Plan Deviations/Changes

Project Name: SS_WDS_SWD #517 to serve Falcon Falls East 2nd Addn, Ph 1

Project No: 468-2023-031005_448-2023-031003_468-2023-085551

Description of changes made from the plans during construction

LINE 2

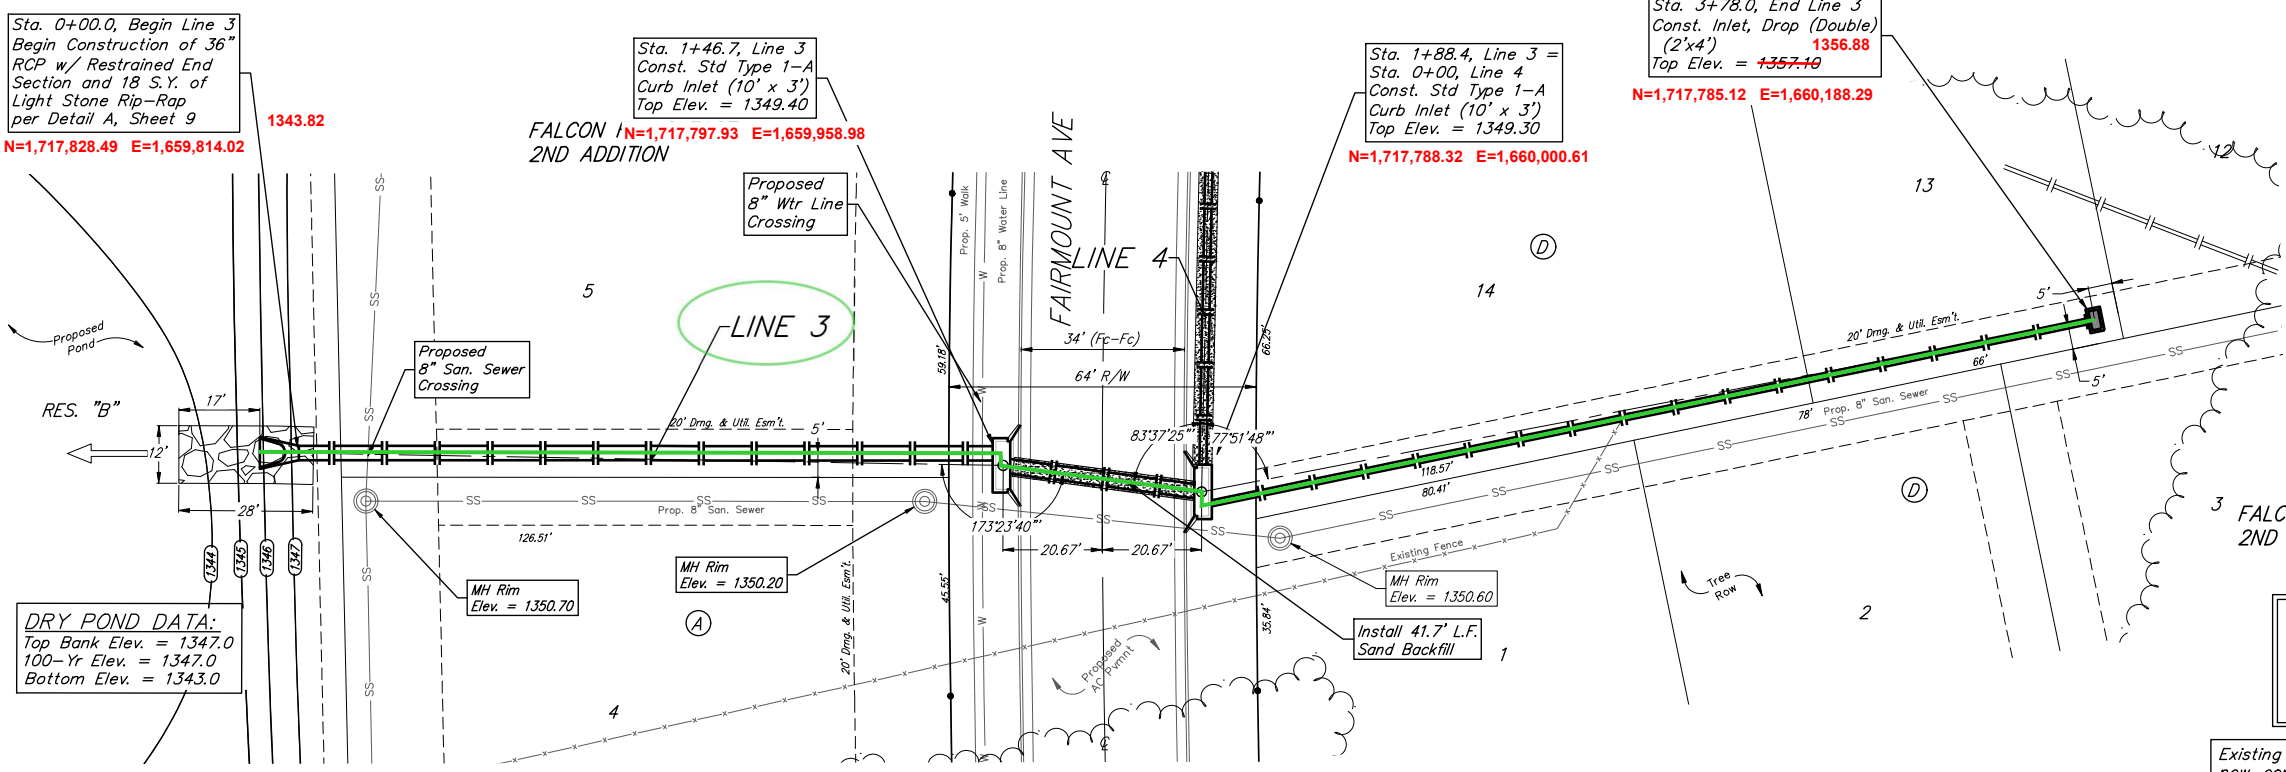
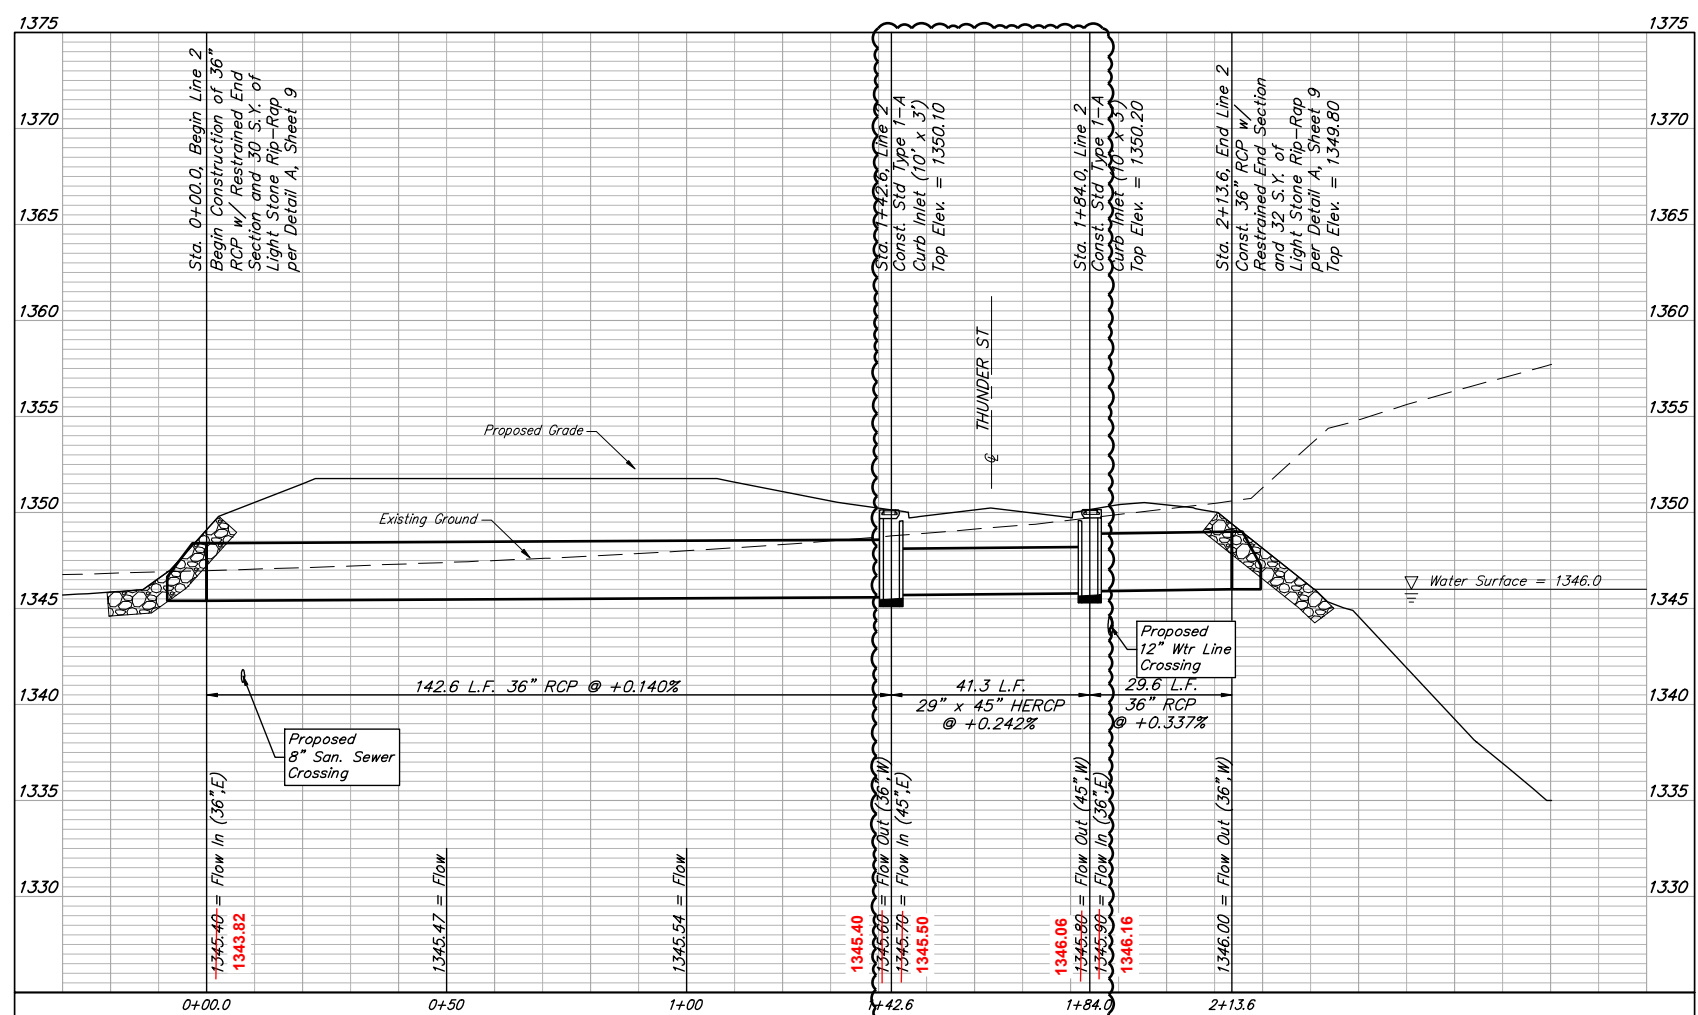
- ~~1. Water Line #3 - Sta. 4+40.56: 22.5 degree fitting eliminated.~~
- ~~2. Water Line #1 - Sta. 0+05: 11.25 degree fitting eliminated.~~
3. SWS Line #2 - Sta. 1+42 to Sta. 1+84: Replaced 36" RCP with 29"x45" HERCP per C.O. #1.
4. SWS Line #3 - Sta. 1+46 to Sta. 1+88: Replaced 36" RCP with 29"x45" HERCP per C.O. #1.
5. SWS Line #5 - Sta. 1+45 to Sta. 1+89: Replaced 30" RCP with 24"x38" HERCP per C.O. #1.
- ~~6. SS Line #1 - Sta. 0+00: Manhole raised to 1349.16.~~

REVISION: Pipe between Curb Inlets changed from 36" RCP to 45" x 29" HERCP
 Date: 2/28/2024
 By: AJV

LINE 5

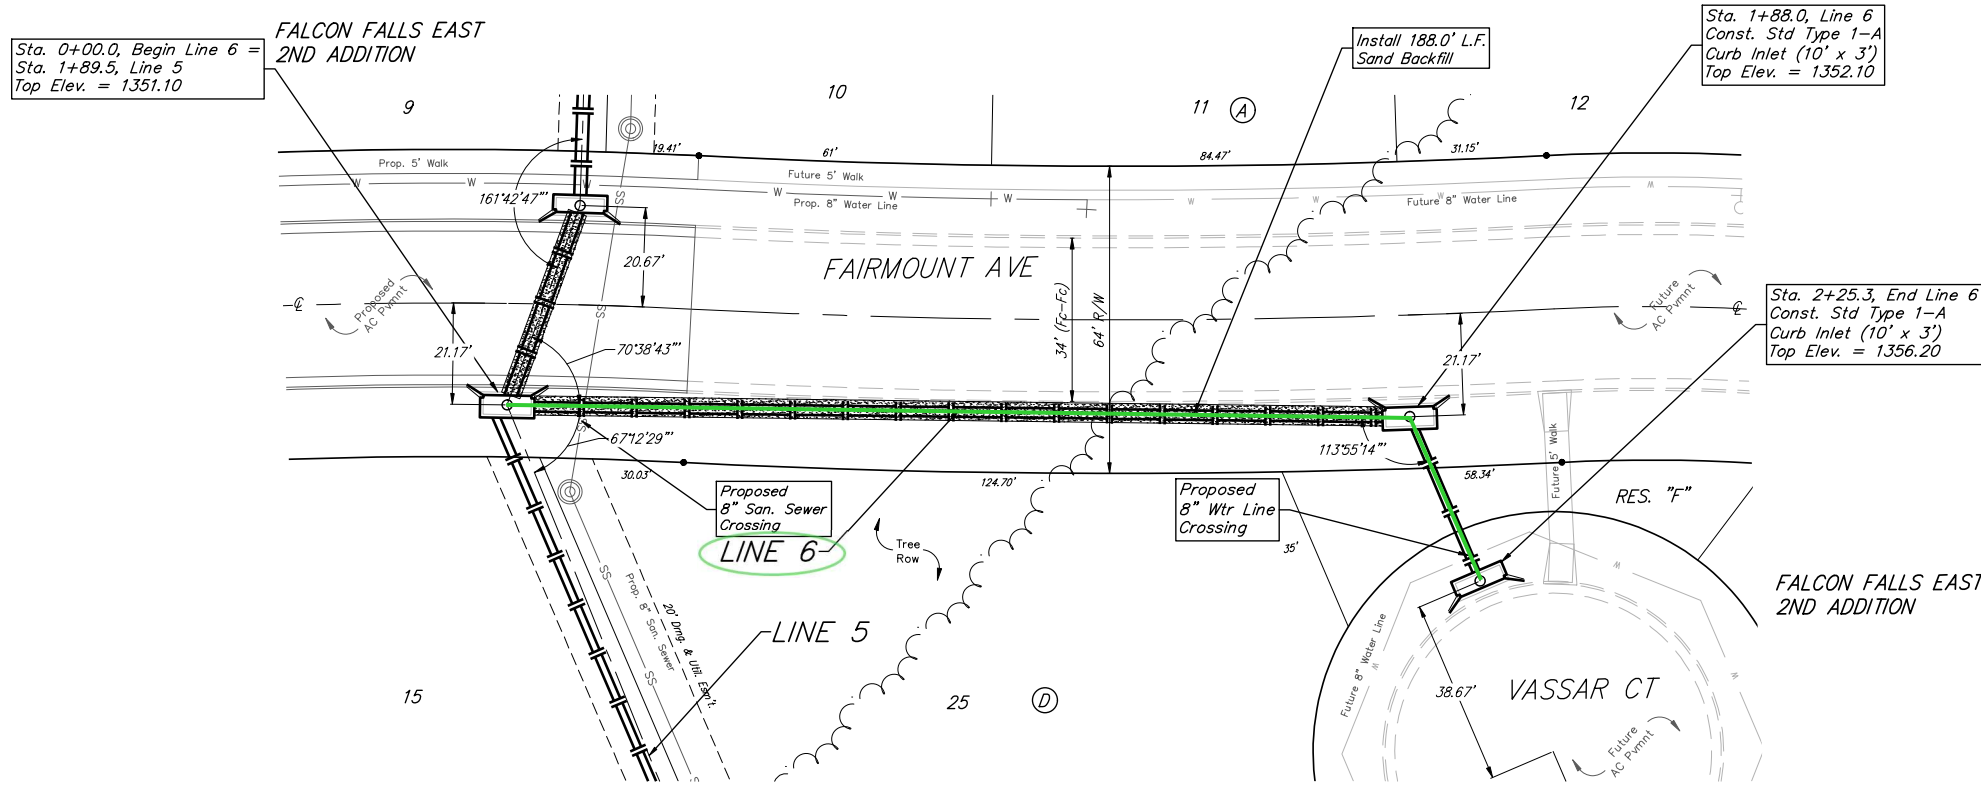
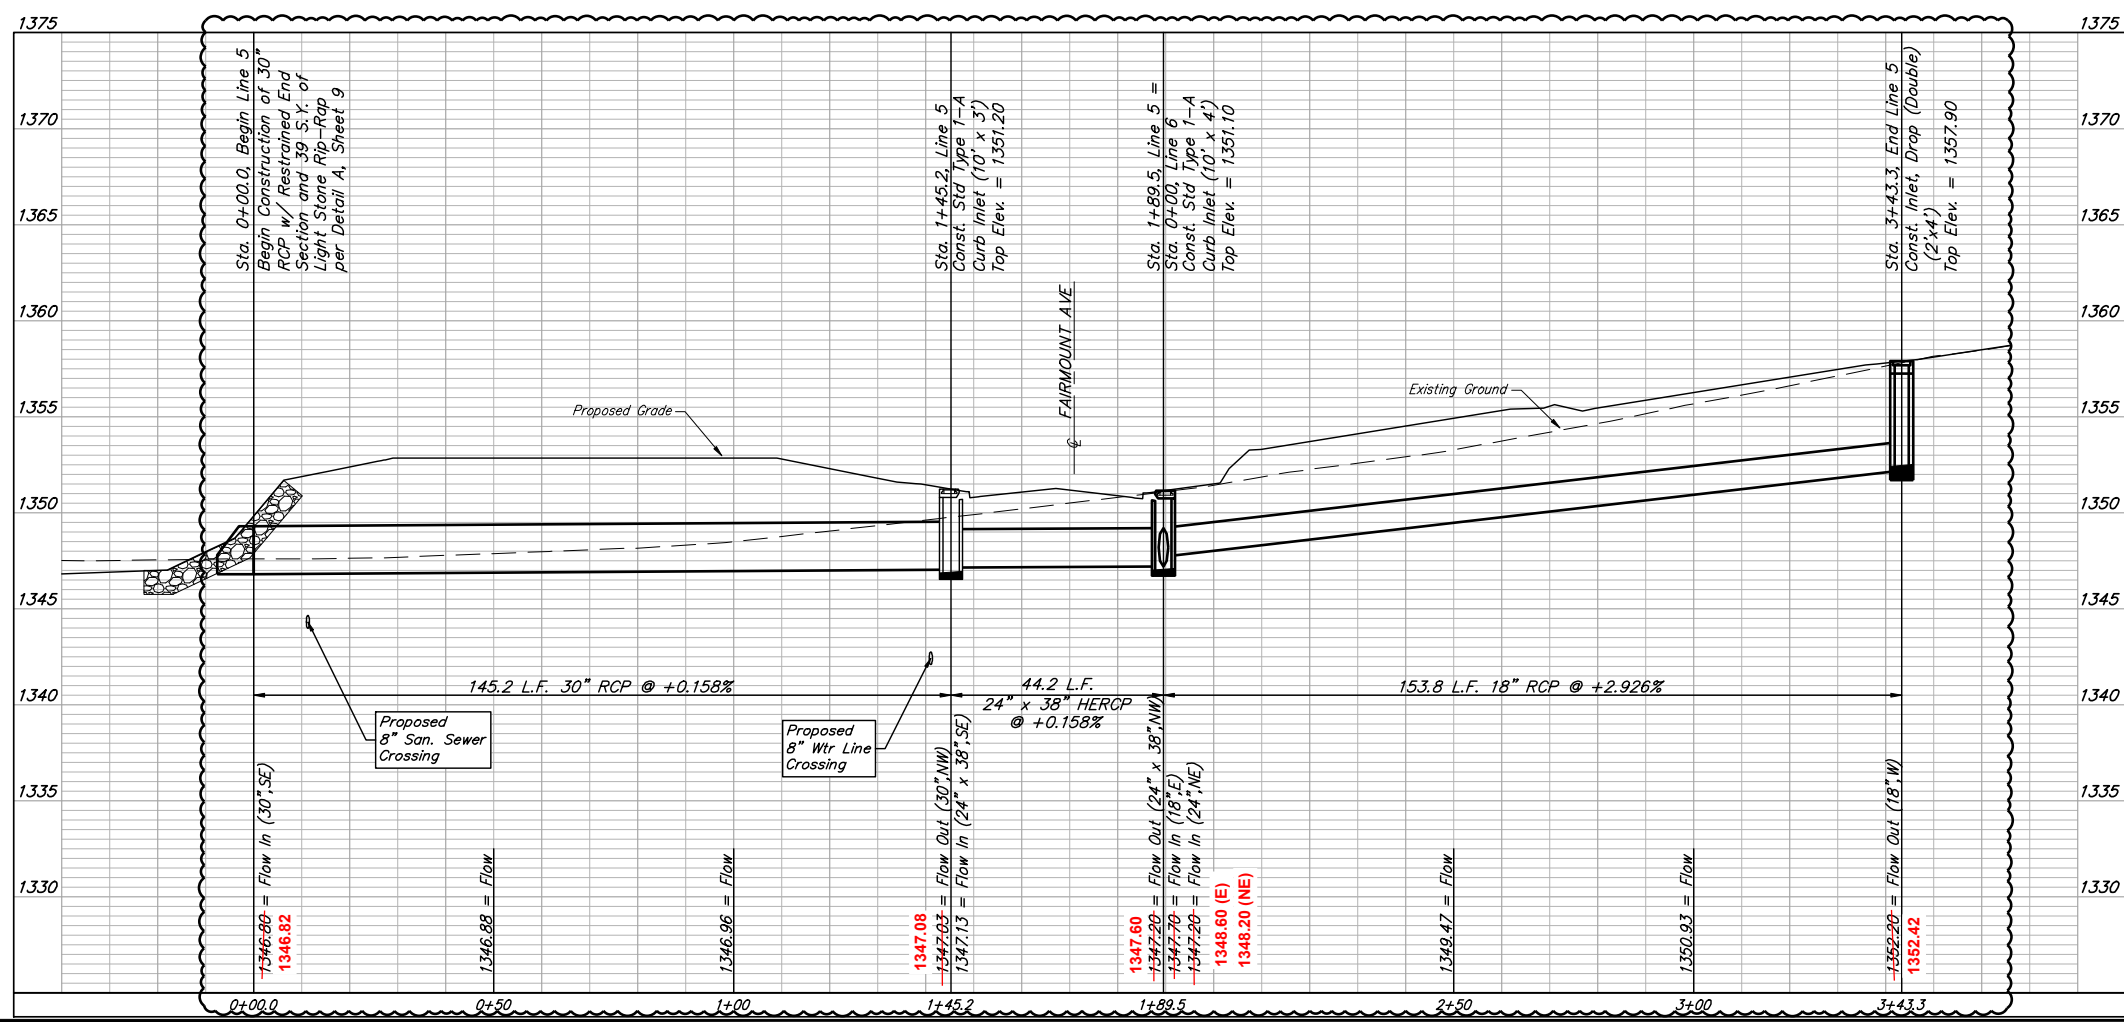
REVISIONS:
 Flow from Sta. 0+00 to 1+89.5 lowered 0.2' Inlet Drop (Double) (2x1) Shifted Southwest 4' Pipe between curb inlets changed from 30" RCP to 38" x 24" HERCOP

MASS GRADING

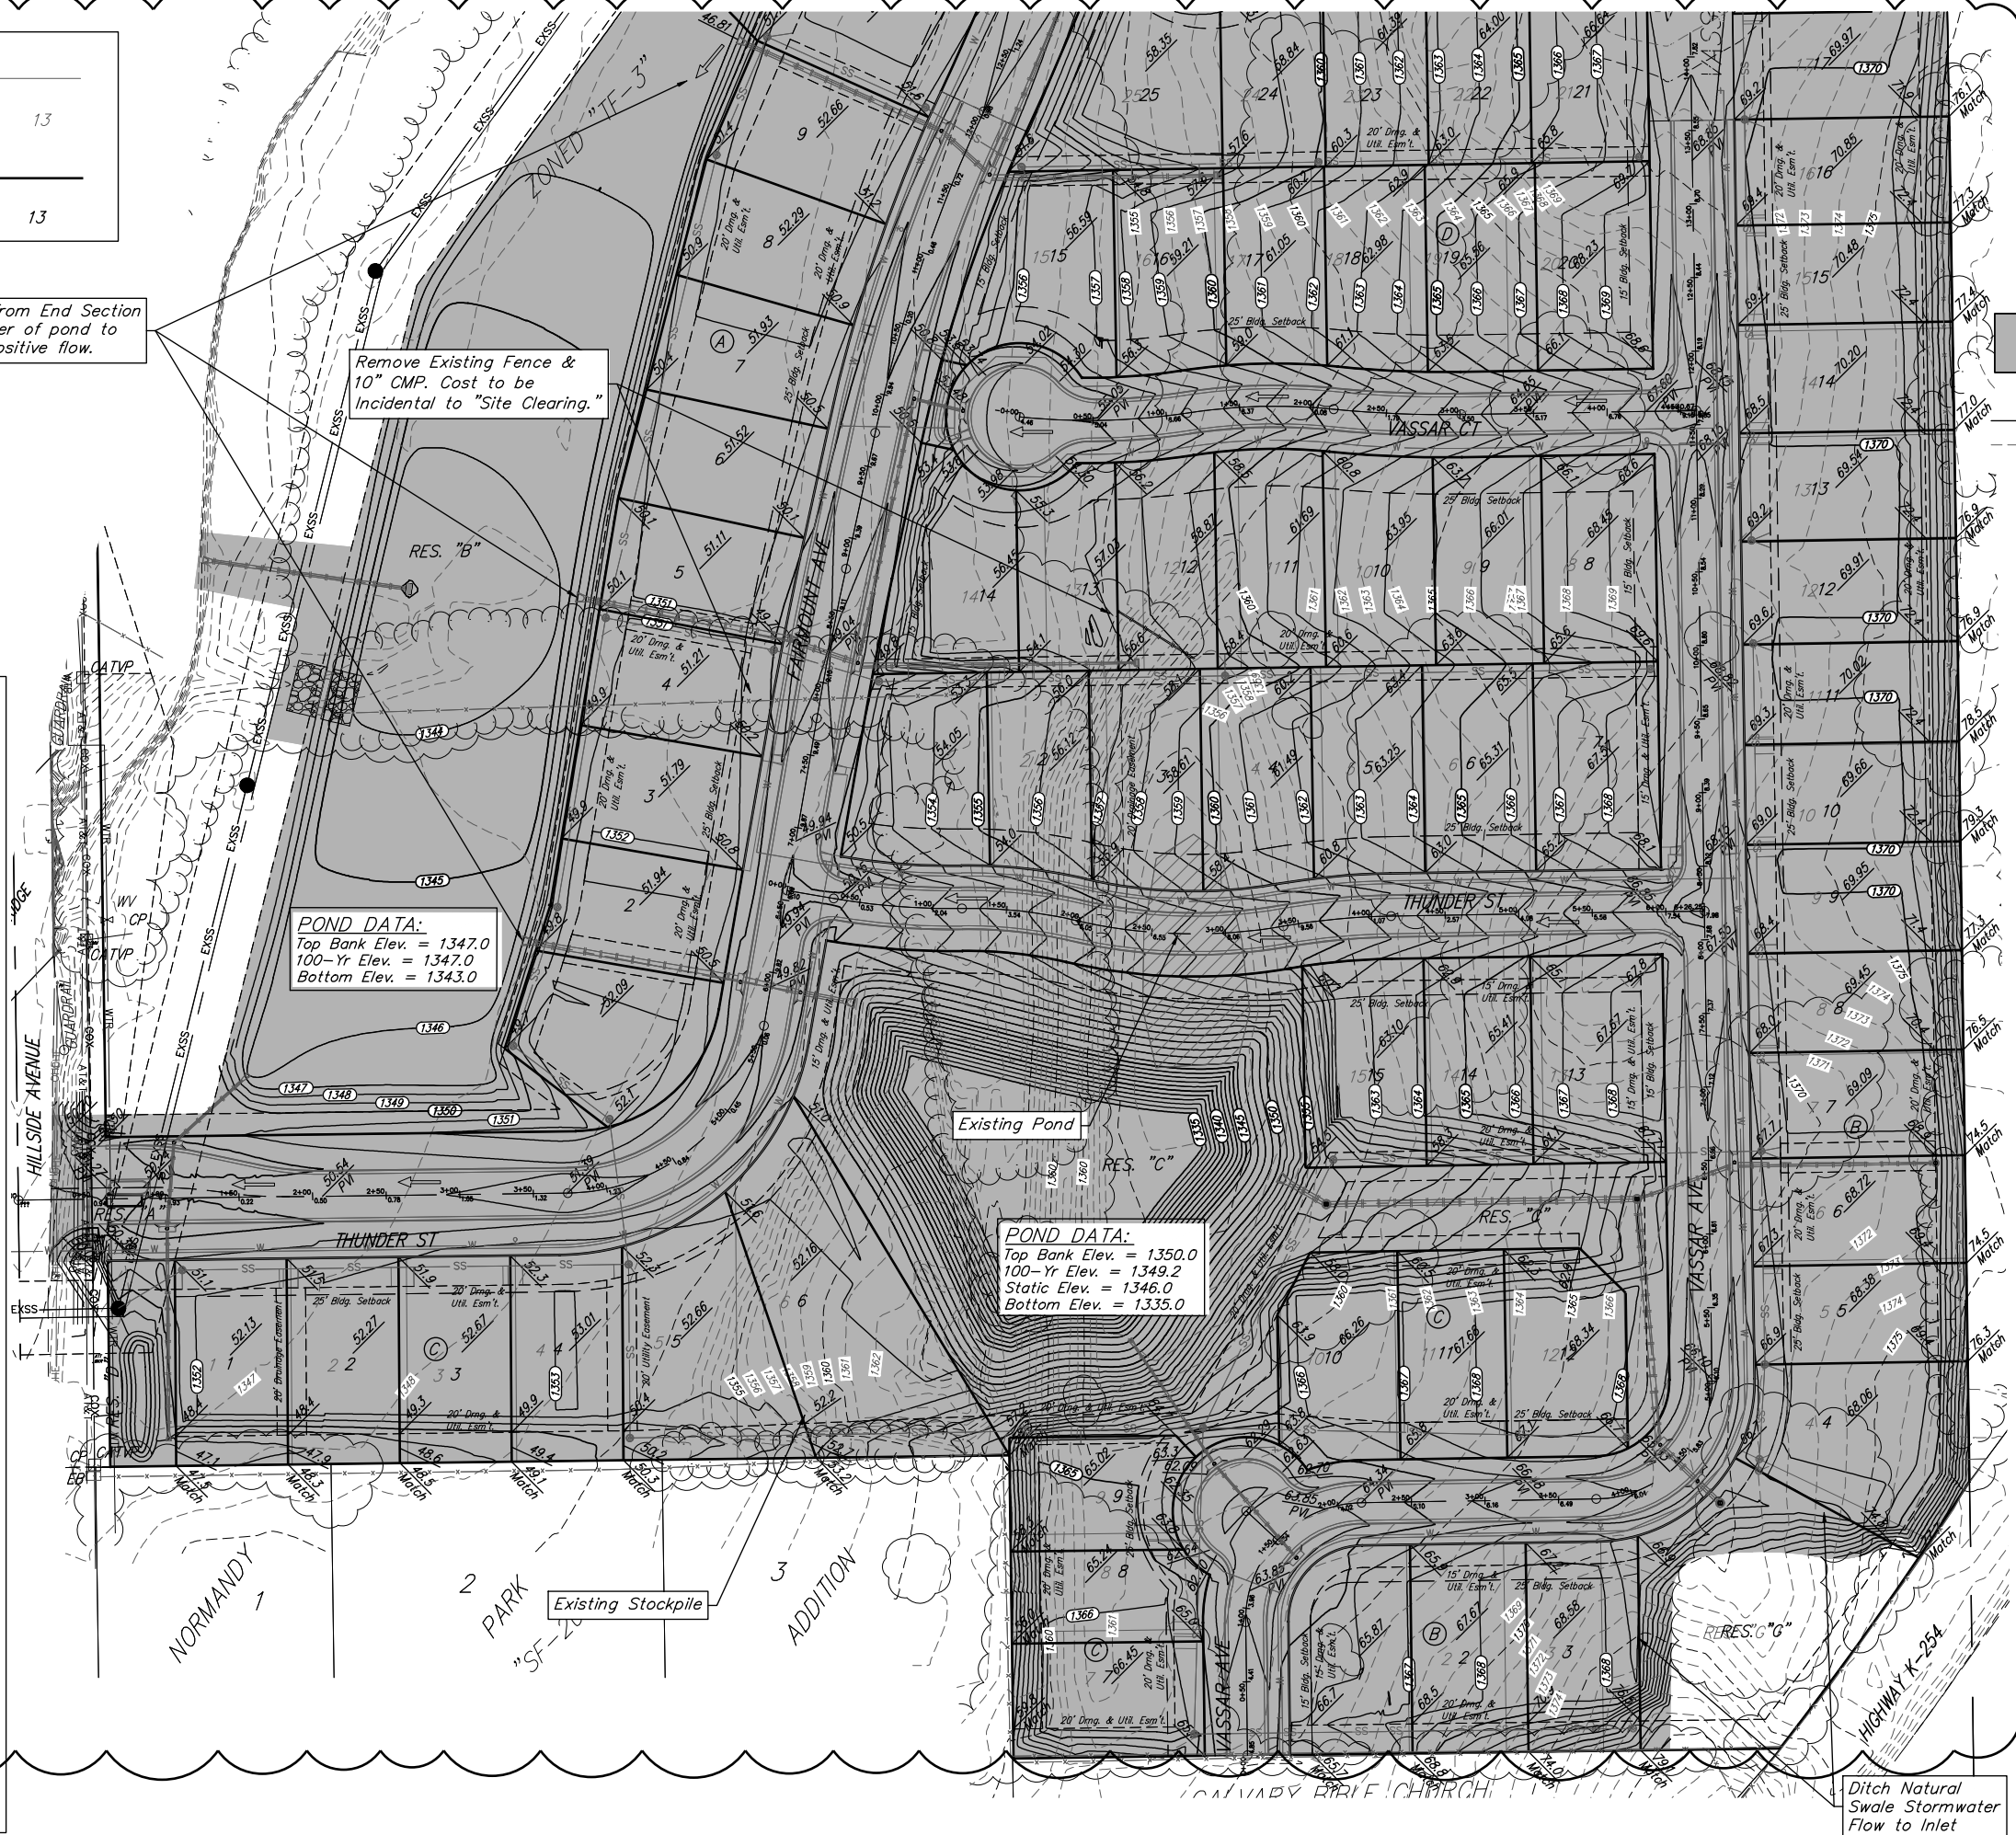
REVISION: Mass Grading, label mass grading contours for regular and lot 14 building area expanded Date: 3/12/2024 By: AIV
